VEHICLE RECALL

G-05514
August 2005

SUBJECT: SAFETY RECALL (U.S., EXPORT)
BATTERY CABLES on 9000 models built 4/1/2002
thru 6/15/2005

Figure 1 – Gap Measurement

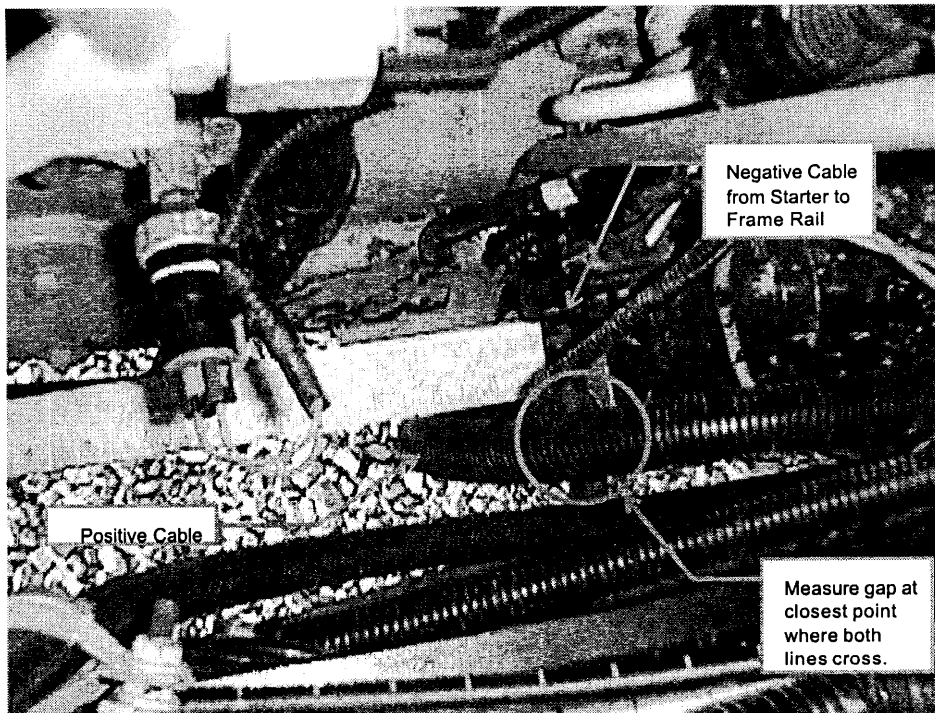
The positive battery cable between the batteries and the starter may rub against an electrical ground cable between the starter and frame rail possibly causing an electrical short and/or fire. This may result in **property damage, personal injury or death.**

1. For Cummins ISM w/ fuel filter, do not perform the gap measurement, skip to the **BATTERY CABLE INSPECTION PROCEDURE**.
2. For Caterpillar, Cummins ISX, and Cummins ISM w/o fuel filter, perform the following gap measurement.
3. Measure the smallest gap between the positive cable's conduit and the closest point to the negative cable bolted to the frame rail. See Figure 1.

4. If the smallest gap is less than 1.5 inches (38mm) continue on to **BATTERY CABLE INSPECTION PROCEDURE**.

Figure 4 – Engine Removed for Clarity

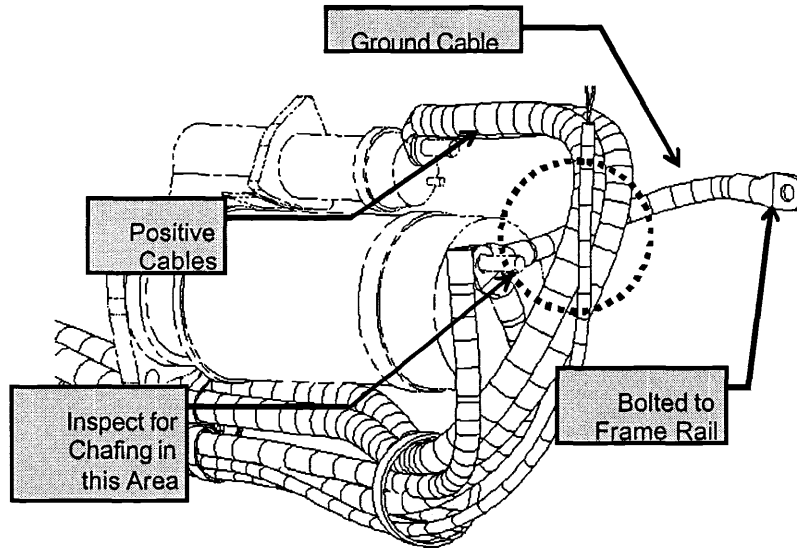
6. For ALL suspect vehicles, if the gap measured above is less than 1.5 inches (38mm), perform the following battery cable inspection procedure.
7. Inspect positive (red) battery cables, conduit and ground cable (black) in areas indicated below:

8. If ANY indication of chafing or rubbing is evident, replace any affected cables and continue to step 11.
9. If there is NO indication of chafing or rubbing, continue on to **SADDLE CLAMP INSTALLATION**.

Figure 5 – w/o fuel filter

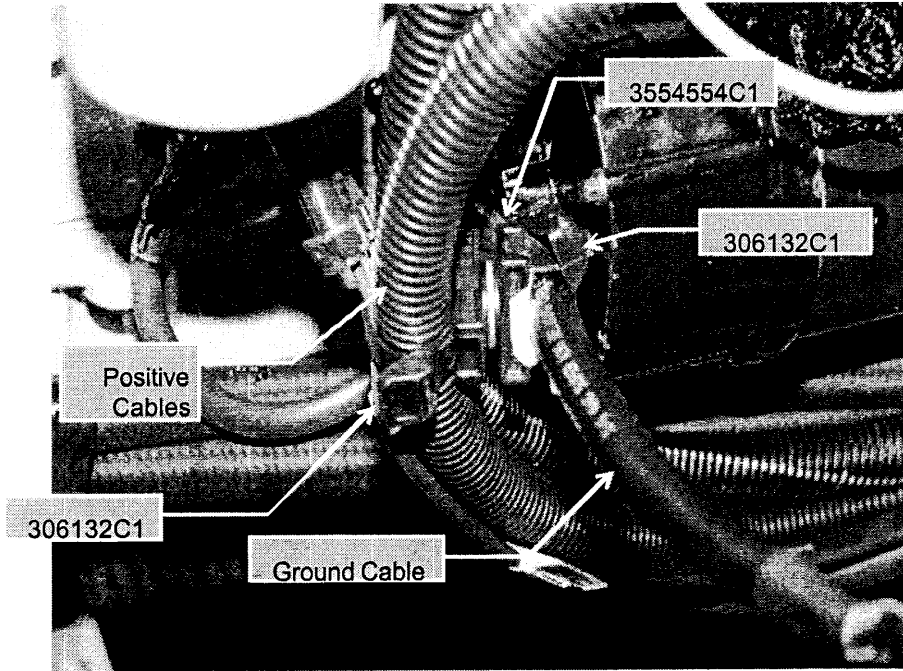
10. For Caterpillar, Cummins ISX, and Cummins ISM (w/o fuel filter), see Figure 5.

11. Install saddle clamp and strap-locks as indicated below:

Figure 6 – Cummins ISM w/Fuel Filter

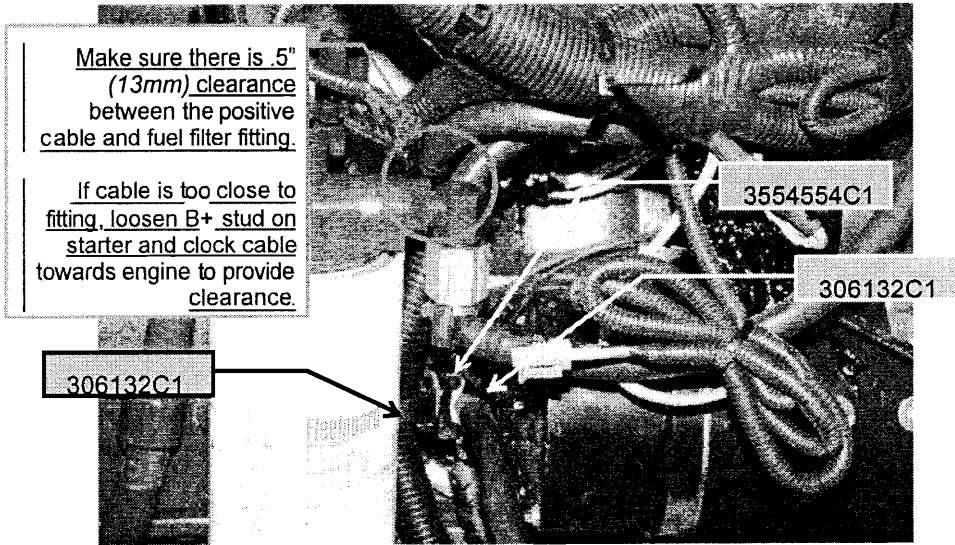
12. For Cummins ISM engines with fuel filter please see Figure 6.

13. Install saddle clamp and strap locks as indicated below.

14. Re-route battery cables between the fuel filter and engine block.

NOTE: Ensure battery cables do not chafe on fuel filter assembly or fittings.
